From: Edward Kisiel [mailto:EKisiel@HNTB.com]
Sent: Thursday, November 10, 2011 3:04 PM
To: 'Maddern, Rodger A.'
Cc: 'Hedrick, Mark'; Malone, Curtice; Gibson, Ornette; 'utilities@ohio.net'; Kenneth Fertal; kishmael@hntb.com
Subject: Cleveland Innerbelt - Commercial Rd (at Central Viaduct - south) - IntelliFiber

ROADWAY GATEWAY
 INNERBELT BRIDGES

PARKING LOT PLAN
GRADING
DOWNTOWN NEIGHBORHOOD PARKING

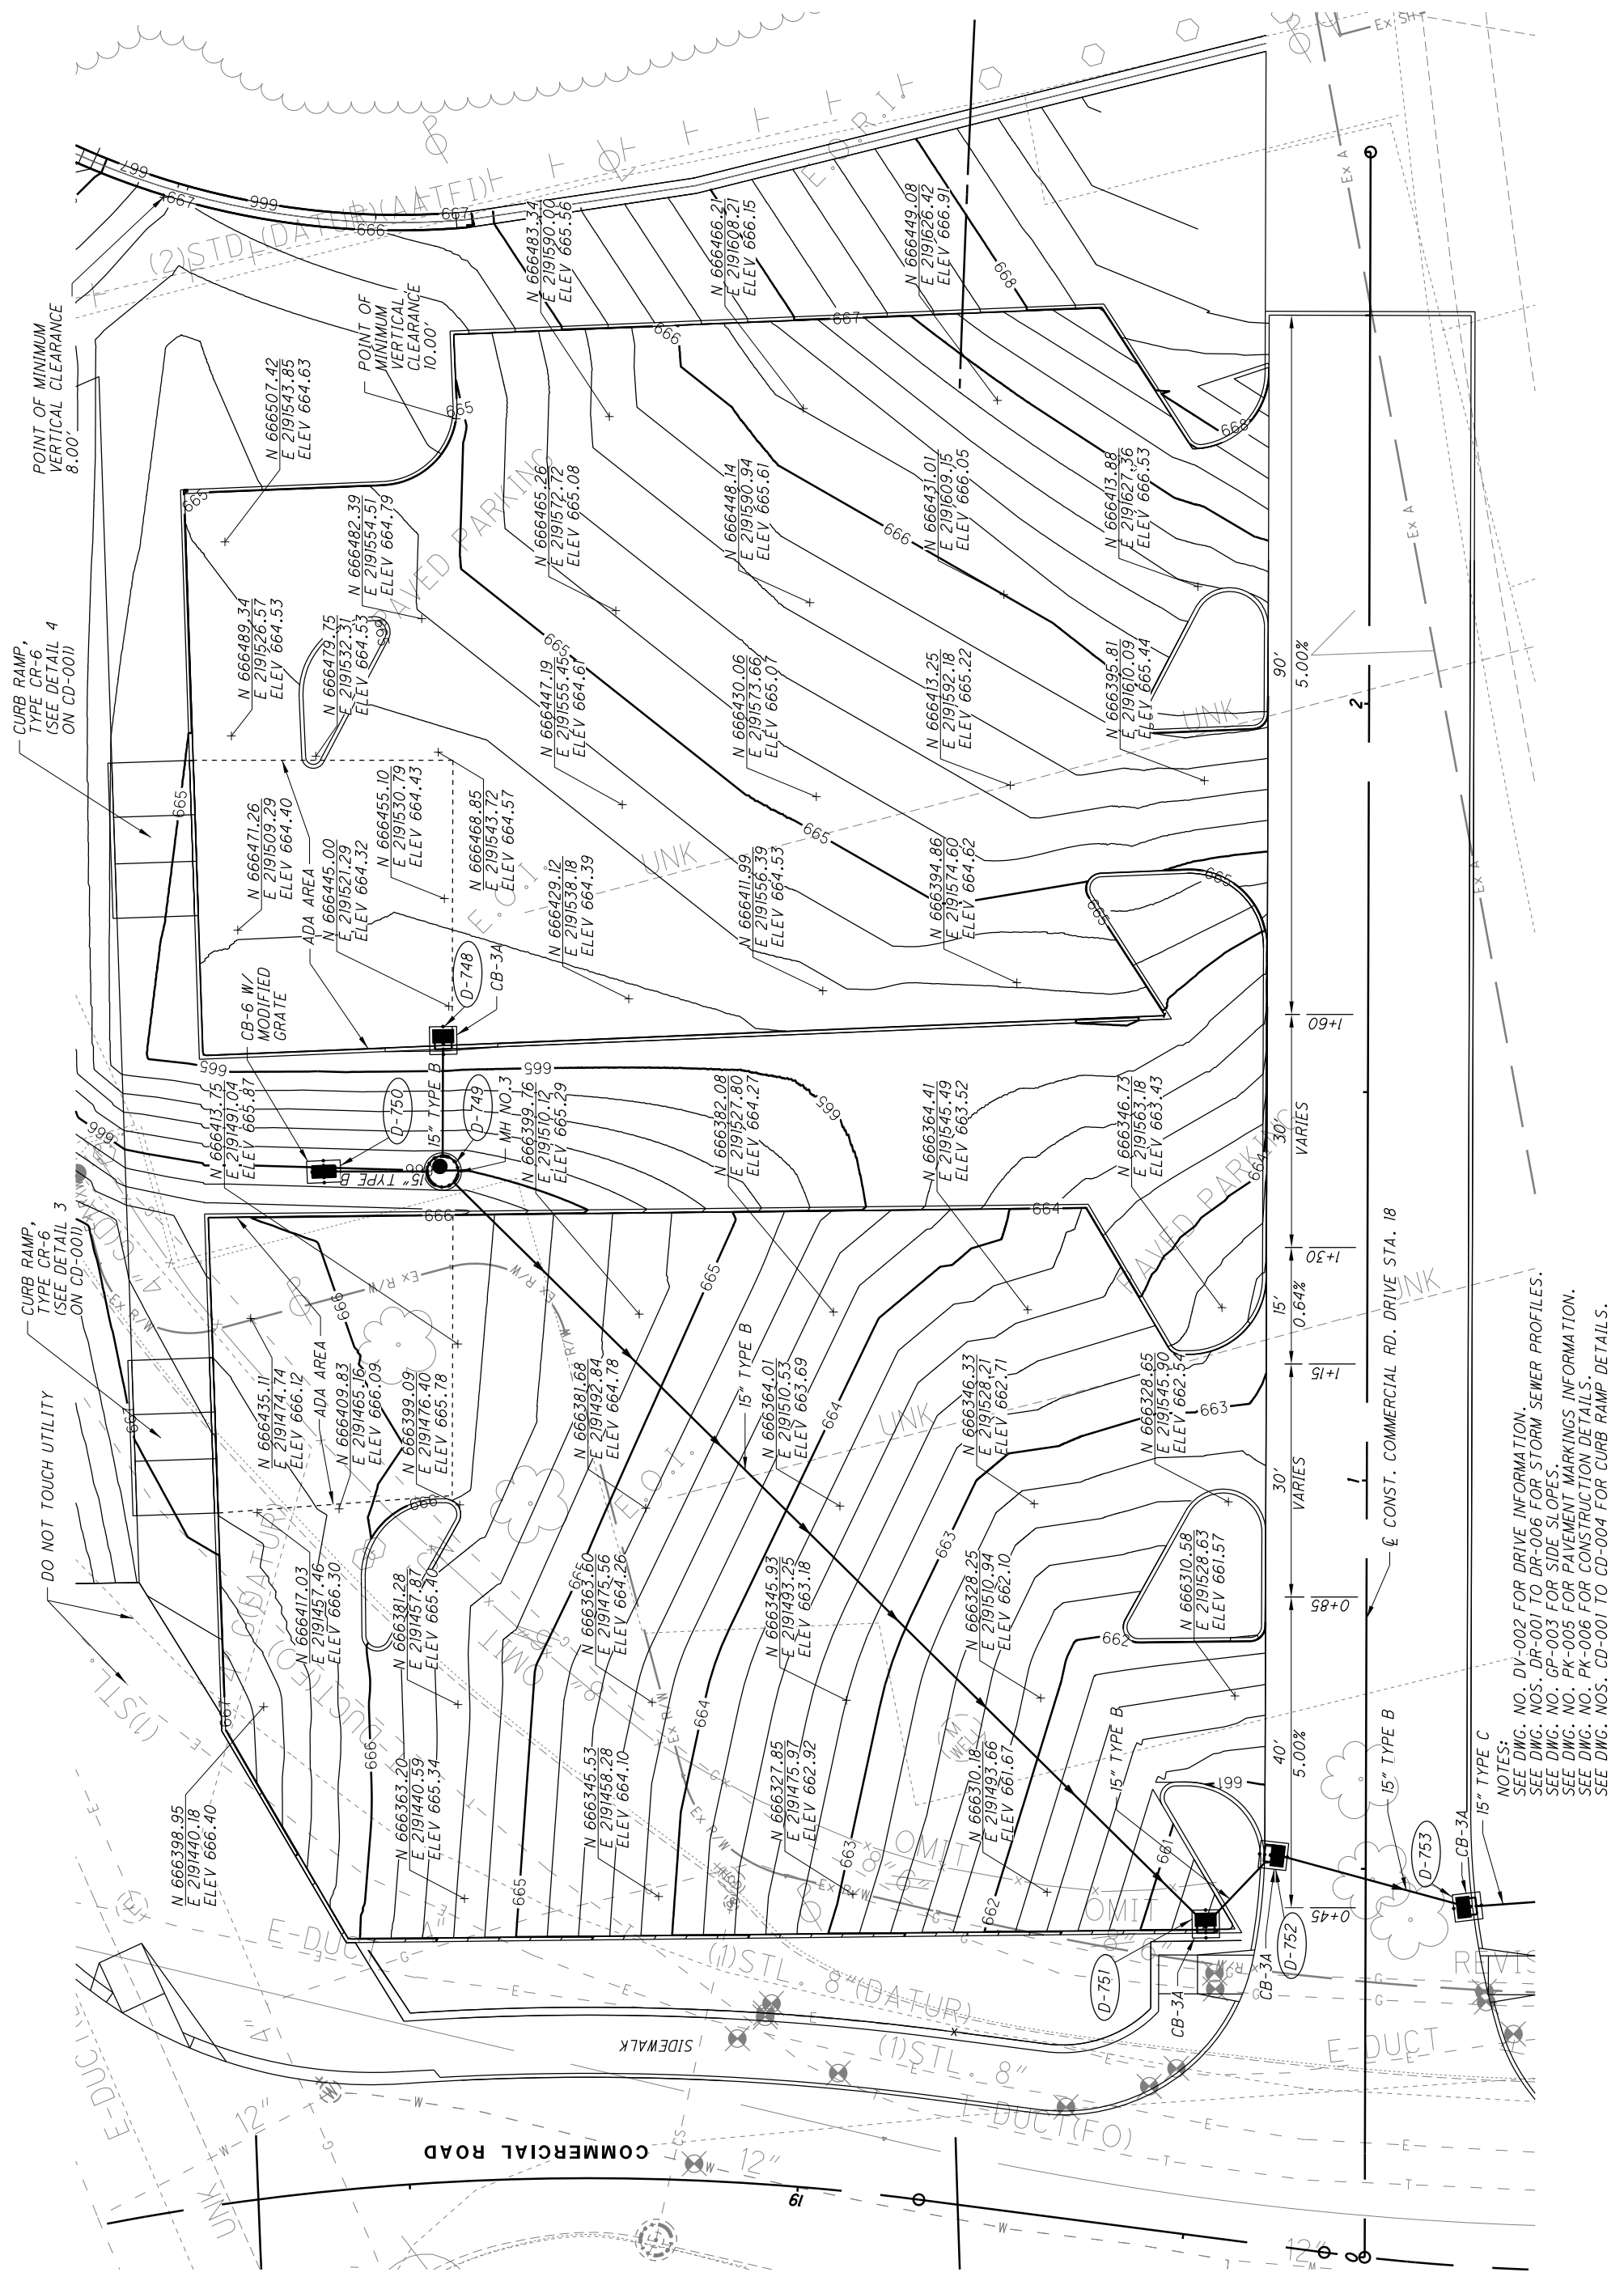
After our discussions in the field last Thursday, 11/03 about IntelliFiber duct run, I made a call to Rick Colello and he confirmed ducts were built approx. having depth of cover at 36" requiring your duct run to be lowered (as we discussed) through the Gateway parking lot, see attached PDF. Not much can be done about raising or adjusting parking lot grading to mitigate since the slope is maxed out. Also noticed clearance might be getting tight on Commercial Rd. (I can provide more data on this if needed).
